Re: Vienna Market

This letter is to serve as a narrative to the changes being proposed specifically to the commercial retail space façade and the corner park per the Board of Architectural review meeting. These items were deferred by the board:

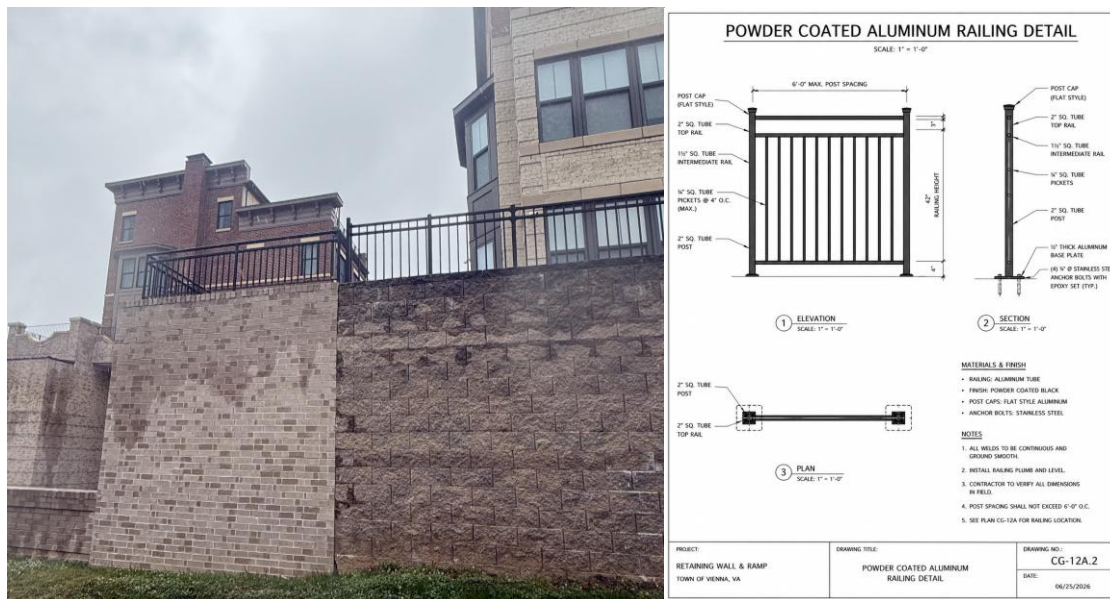
10. Comment: Move forward with the proposed lighting as it exists provided lighting specifications are included in the BAR application.

Response:

[Attached](#) is a link to the light specifications for the wall sconces on the outside of the building.

[Attached](#) is a link to the light specifications for the parking garage lights.
